Pre-Application Letter

Project Number: PRE2023-0072

Scope of Work: NEW MULTI-FAMILY BUILDING

Site Address: 1221 LINCOLN ST

FIREFLOW INQUIRY / RESPONSE FORM

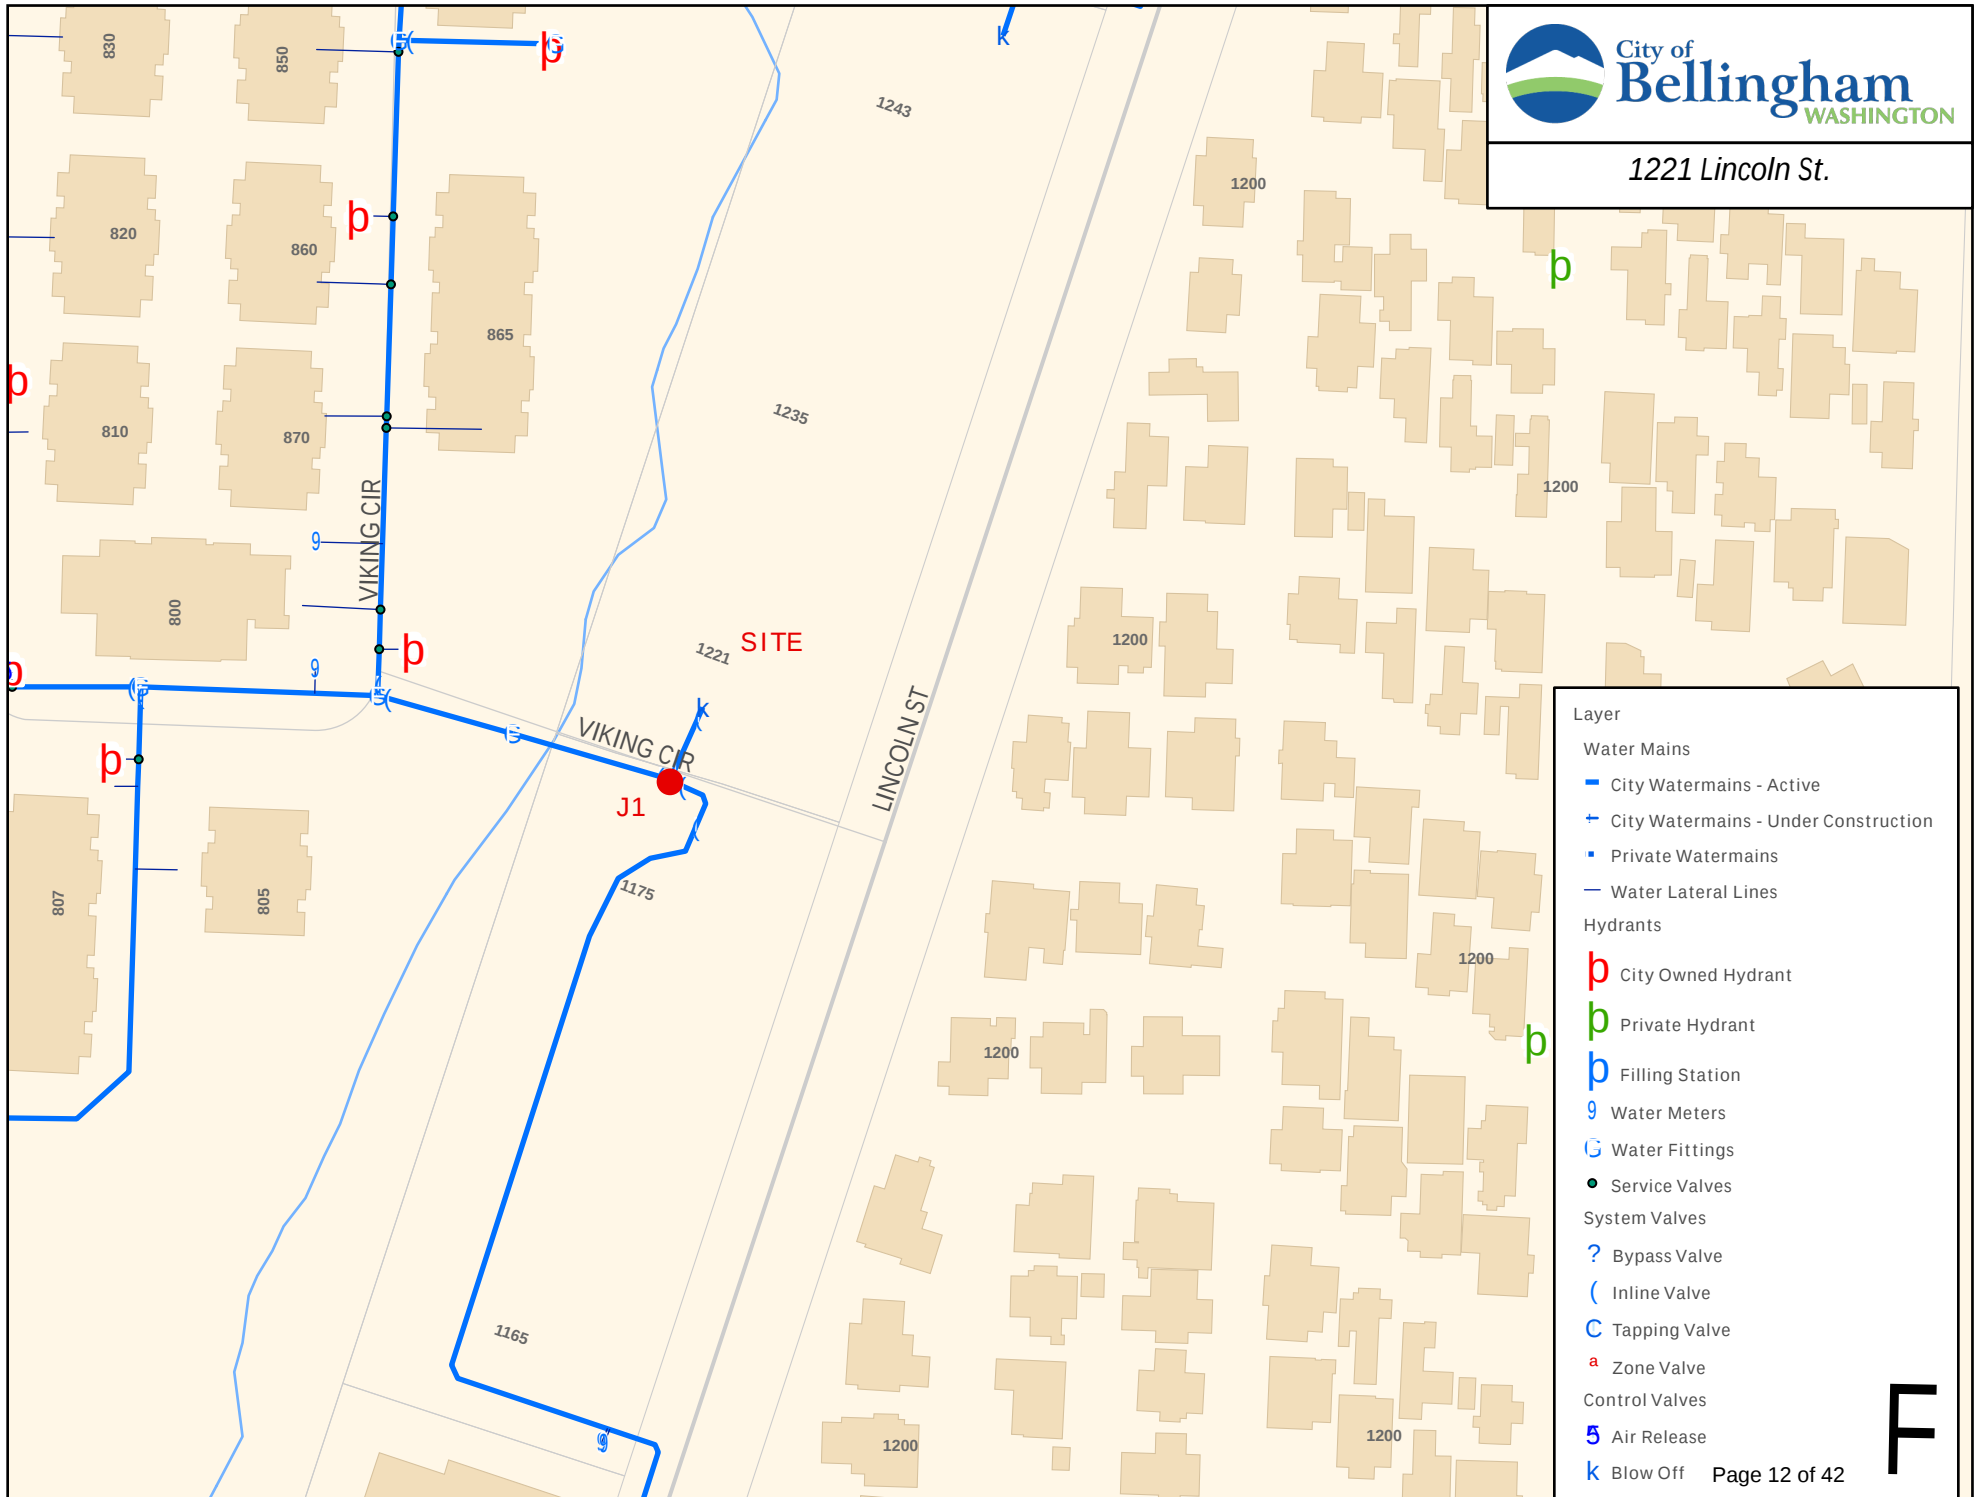
****This data was generated by computer modeling and is provided for preliminary design work only. If the flows provided below only meet your required flow by a small margin it is recommended that you hire a professional and have a field flow test conducted under the supervision of the Public Works Department. The City of Bellingham will not be held responsible for any sprinkler system and/or Fire Flow that does not pass Fire Department inspection. Please contact the Public Works Department for more information.**

J1

Static Pressure = 129psi

Residual Pressure @ 1000gpm = 123psi

Residual Pressure @ 2000gpm = 109psi

Residual Pressure @ 3000gpm = 89psi

Flow exceeds 5000gpm @ 20psi
